Project	<b>IEEE 802.16 Broadband Wireless Access Working Group</b> < <a href="http://ieee802.org/16">http://ieee802.org/16</a> >	
Title	Amendments to the Multi-hop Relay System Evaluation Methodology Document	
Date Submitted	2006-11-14	
Source(s)	Gamini Senarath, Mark Naden, Dean Kitchener, G.Q. Wang, Wen Tong, Peiying Zhu Hang Zhang, David Steer, Derek Yu	Voice: 1-613-763-1315 [mailto: <a href="mailto:wentong@nortel.com">wentong@nortel.com</a> ]
	Nortel 3500 Carling Avenue Ottawa, Ontario K2H 8E9	
Re:	Call for Technical Proposals regarding IEEE Project P802.16j (IEEE 802.16j-06/027)	
Abstract	Correction to the path loss models in 802.16j-06/.013r1	
Purpose	Address a missing path loss models and some editorial corrections to make the applicability of the models clear in P802.16j-06/13r1 document.	
Notice	This document has been prepared to assist IEEE 802.16. It is offered as a basis for discussion and is not binding on the contributing individual(s) or organization(s). The material in this document is subject to change in form and content after further study. The contributor(s) reserve(s) the right to add, amend or withdraw material contained herein.

# Amendments to the Multi-hop

Figure 3, BS-RS NLOS (ART to BRT)

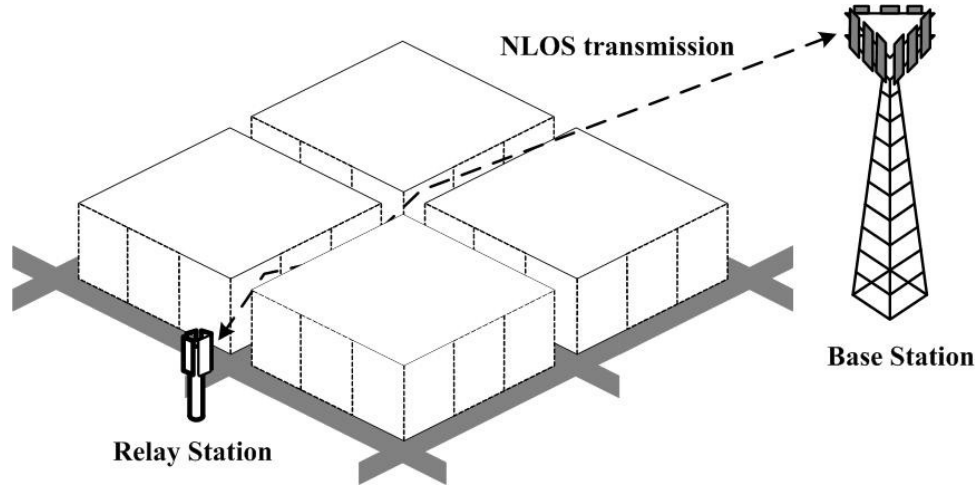
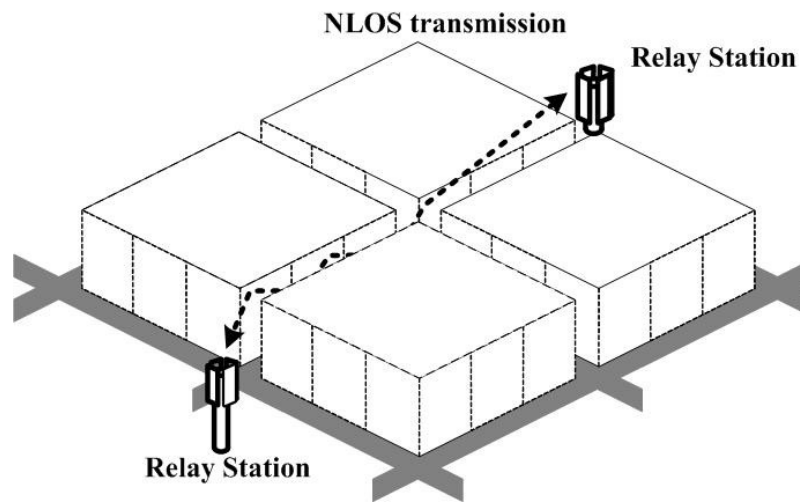
- c) The type E model does not have adequate parameters to be used for the simulations. In order to have alignment across different simulations we propose to have some parameters specified.  
Proposed Text Change: Proposed Text Change: The Text marked in Blue color included in Section 2.1.2.3 below should be inserted into Type E model description in the 802.16j-06/013r1 document.

For the urban NLOS case which is shown as the examples in Figure 4 and 5, the COST 231 Walfisch-Ikegami model is recommended and given in [14].

Parameter values to be used for this model are provided below. The use of these values is not mandatory.

*Building spacing,  $b = 60\text{m}$  (this is the spacing between building centres)*

*Street width,  $w = 12\text{m}$  (this is the spacing between building faces)*

*Street orientation = 90 degrees*

*Average rooftop height,  $h_{\text{roof}} = 25\text{m}$*
